Access Compliance Report

Public Rights-of-Way

(Curb Ramps)

Intersection ID: 16044	Main Street: BARRINGER_DR	Cross Street: PRESSLEY_RD	Location: NW
ADA ID: 8431F481A46F	Ramp Type: Perp	Initial Pass/Fail: Fail	Overall Compliance: No
Severity Score: 12.5			
Codes/Mitigation Info/Possible Solution		Field Measurements/Component Compliance

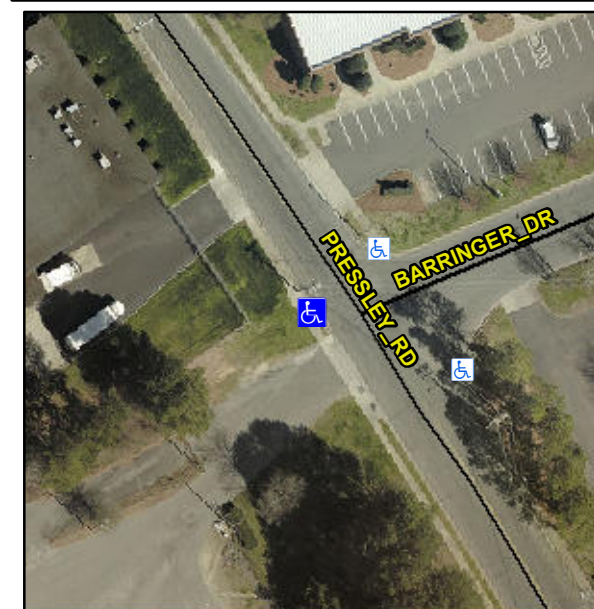
Not Found, R304.2.2

Compliance	Description	Data	Compliance	Description	Data
N/A	Ramp Length (in)	27.0	No	Ramp Slope (%)	8.4
Yes	Ramp Width (in)	56.0	Yes	Ramp XSlope (%)	0.5
N/A	Flare Type LT	N/A	N/A	Flare Type RT	N/A
N/A	Flare Slope LT (%)	N/A	N/A	Flare Slope RT (%)	N/A
N/A	Flare Traversable LT?	N/A	N/A	Flare Traversable RT?	N/A
N/A	Landing Length (in)	N/A	N/A	DWS Provided?	N/A
N/A	Landing Width (in)	N/A	N/A	DWS Contrast?	N/A
N/A	Landing Slope (%)	N/A	N/A	DWS Length (in)	N/A
N/A	Landing X Slope (%)	N/A	N/A	DWS Full Width?	N/A
N/A	Landing Curb? (Y/N)	N/A	N/A	DWS Offset (in)	N/A
N/A	Shared Landing?	N/A			
N/A	Gutter Ponding?	N/A	N/A	Gutter Slope (%)	N/A
N/A	Gutter Lip Ht (in)	N/A	N/A	Gutter X Slope (%)	N/A
N/A	Painted X Walk1?	No	N/A	Painted X Walk2?	N/A
	X Walk 1 Direction	To NE		X Walk 2 Direction	N/A
N/A	X Walk 1 Width (in)	N/A	N/A	X Walk 2 Width (in)	N/A
	X Walk 1 Slope (%)	8.1		X Walk 2 Slope (%)	N/A
	X Walk 1 X Slope (%)	4.2		X Walk 2 X Slope (%)	N/A

Remove & Replace Entire Ramp.
